INDIANTOWN COGENERATION PROJECT

Site Certification Application

TO: Power Plant Siting Review Committee
FROM: Buck Oven *HO*
DATE: April 21, 1992
SUBJECT: Modification Request-Indiantown Cogeneration
Project, PA 90-41, Module 8041

SUBJ: Indiantown Cogeneration Project - Modification request dated 4/20/92

Figure 1 : Conceptual Design: Caulkins Alternative Intersection with SR710

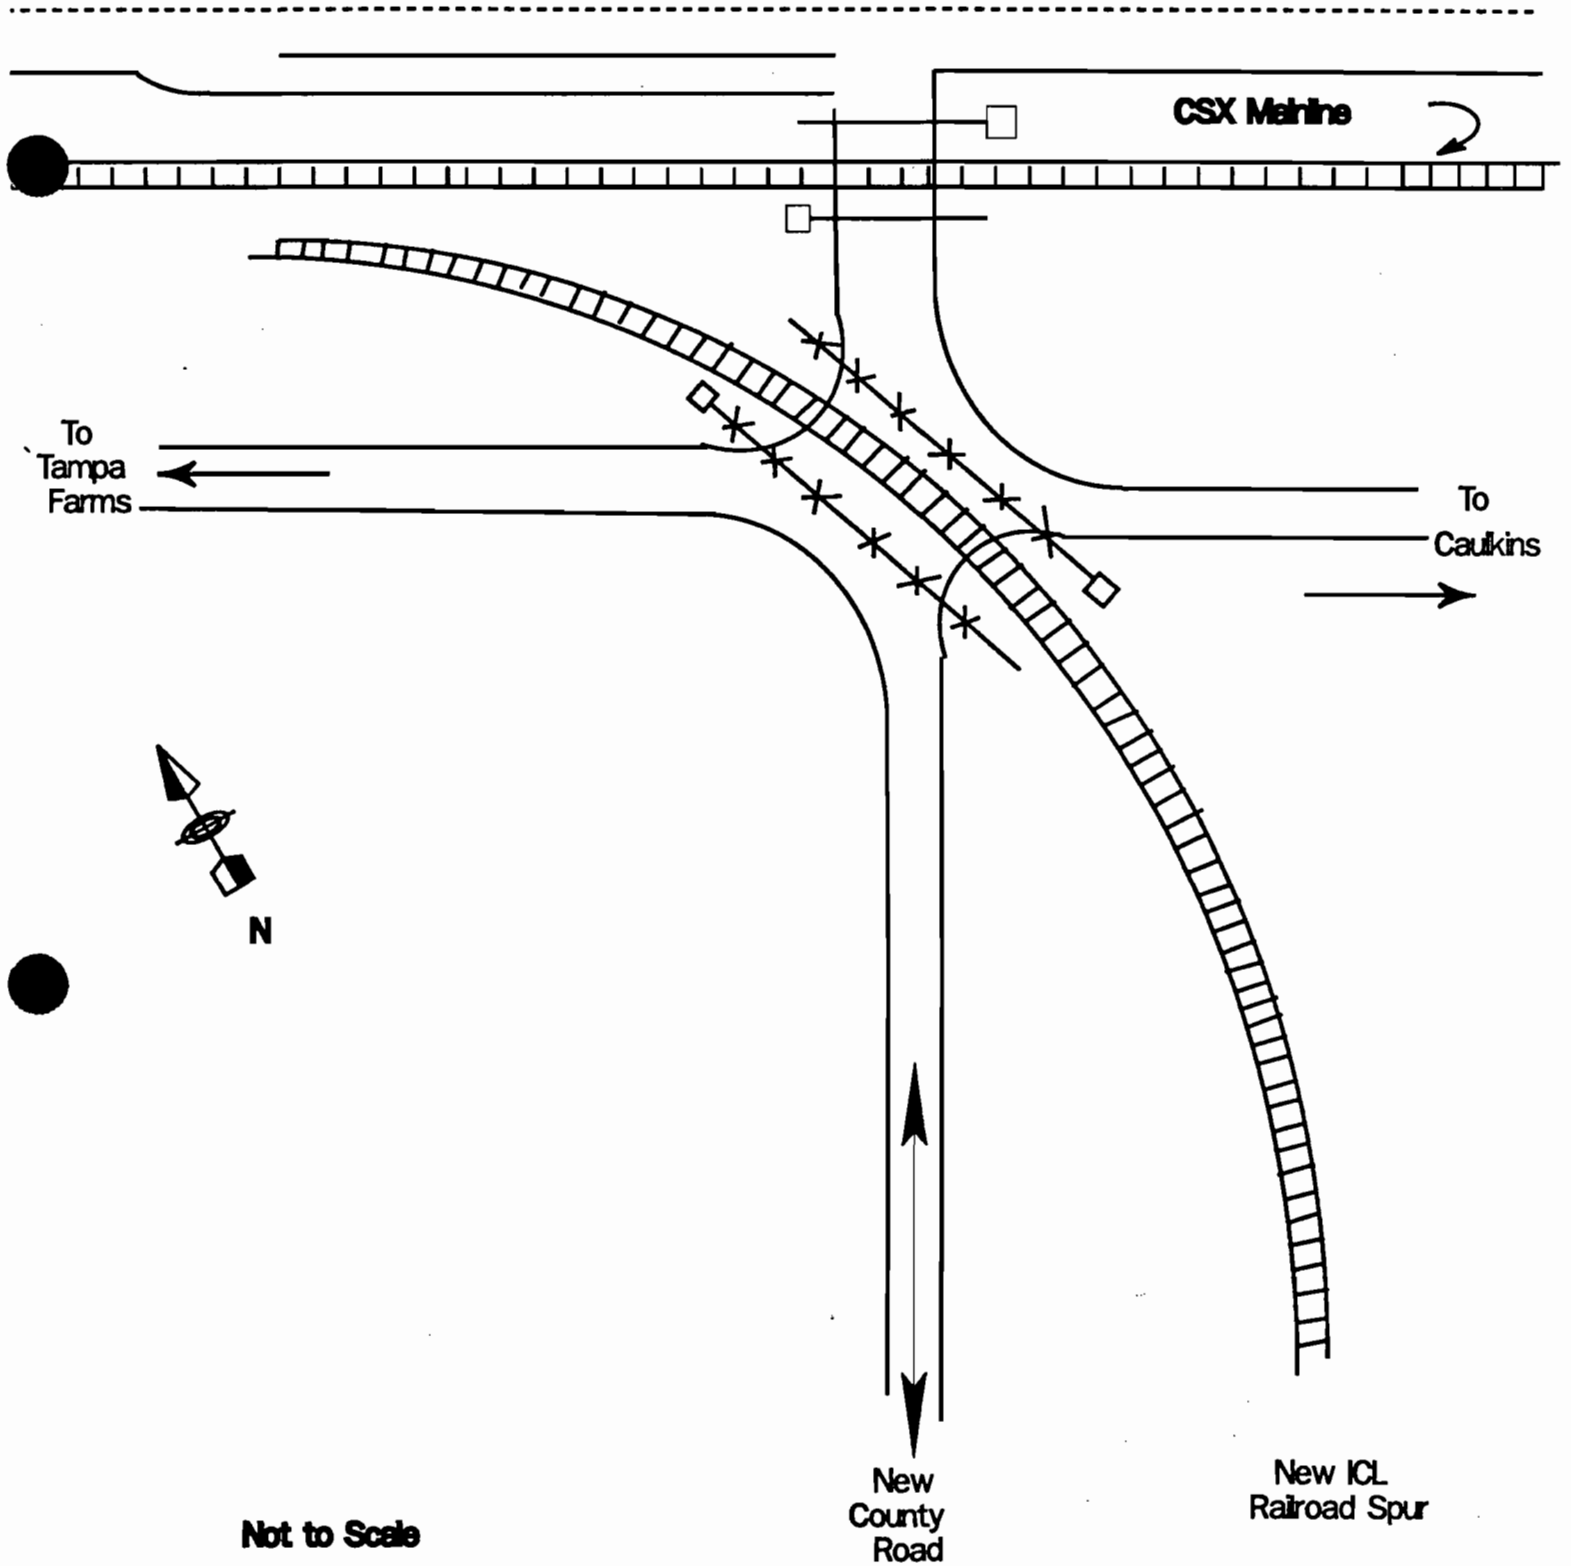
Traffic Analysis. Figure 1 illustrates the intersection between the new County Road and SR 710, as designed for this alternative. Doug Coomer, Transportation Engineer, Kimley Horn, conducted the traffic analyses of the project for the SCA and Sufficiency Responses. He has analyzed the impacts of this proposed alternative and concluded that no increase or change in impacts to rail or vehicular traffic is expected as a result of constructing this alternative (see attached report, Appendix A).

NO.	DATE	REVISIONS	BY	CHK.	DES.	ENGR.	PROJ. ENGR.	APPR.
SCALE: 1" = 300'		DATE: 9-11-90	DESIGNED:	DRAWN:	RW			
JOB NO.		DRAWING NO.		REV.				
20524-001		COA 0001A		I

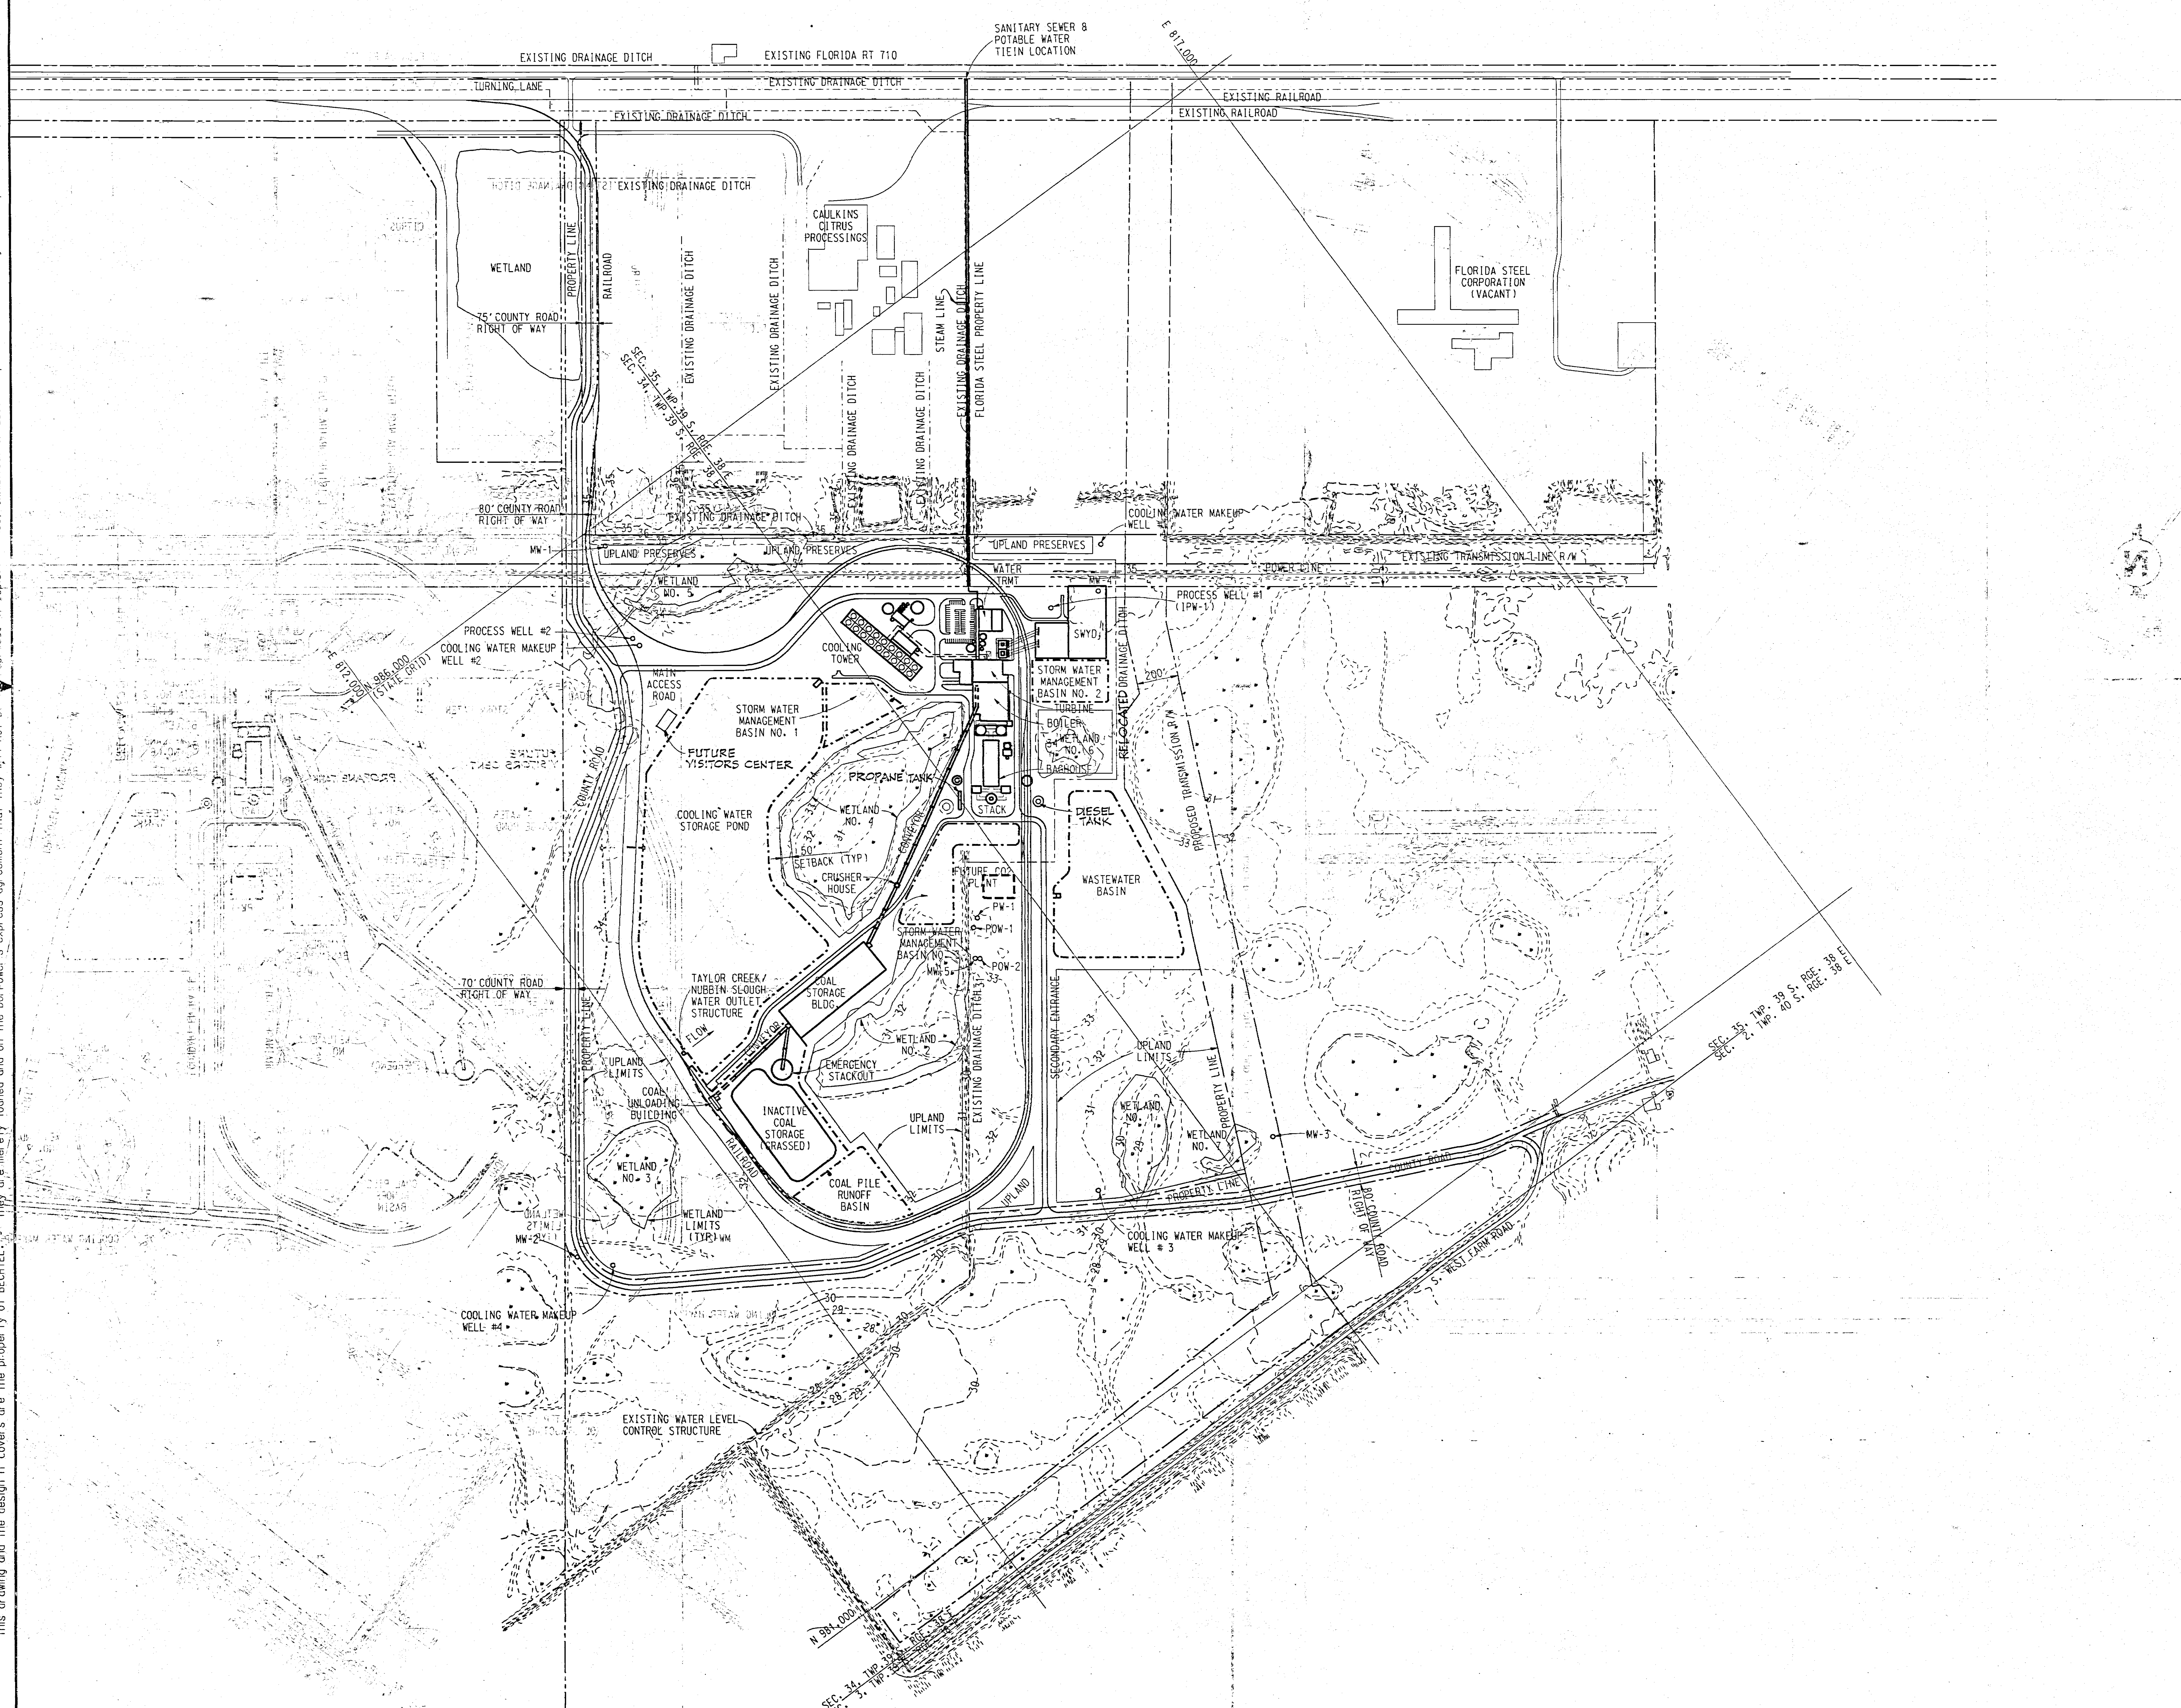
This alternative route is illustrated on the revised site layout (Drawing COA 0001A), attached. The rail spur would parallel the new County Road from the intersection with the CSX railroad and enter the ICP site at the northwest corner. The rail line will permanently occupy approximately 2 acres of land. Construction of the rail will require an additional 30 feet of corridor width, which will be used as a drainage swale along the eastern edge of the rail bed, once construction is completed.

During continuing design of the new County road, it became apparent that repositioning the portion of the road south of Wetland 1 further to the south by 50 feet would provide a larger buffer to the wetland and would also make use of previously disturbed areas along the existing dirt road. Revised Drawings COA 0001A and B show the relocated road, with the original site boundary.

The ash storage silo is shown on Revised Drawings COA 0001A and B, the revised Site Layouts for each rail spur alternative. The baghouse for particulate control will be resized to accommodate the larger size of the building. The five foot increase in diameter will not produce measurable effects on stormwater runoff characteristics. All current requirements of the certification will be met by this design change.

Revised Drawings COA 0001A and B show the location of the auxiliary boilers, which would vent to a single stack. The emission controls proposed for the original auxiliary boiler (low NO_x burners for NO_x; firing of low sulfur (0.05%) oil for SO₂; combustion controls for CO and VOC's; and use of high quality fuel to limit particulate emissions; all as described in Section 3.4, Volume 2 of the SCA and the April Sufficiency Responses [DER 36, 37, 39, 42, and 44]), would be retained in the redesign of the auxiliary boiler.

ICL therefore proposes to construct two 30,000 gallon propane tanks on the site, to ensure reliable supplies of propane. The tanks will be located adjacent to and west of the main stack, as shown on Revised Drawings COA 0001A and B.

ICL proposes to provide on-site diesel fuel storage for fueling the yard rail engine which will move the rail cars while on site. ICP requests permission to construct a 1,000 gallon above ground tank, which will be sited between the main stack and the wastewater basin on the east side of the secondary exit road, as shown on Revised Drawings COA 0001A and B. Fuel will be delivered by truck approximately once a week.

The revised site layout, as shown on Drawings COA0001A and COA0001B, is approved.
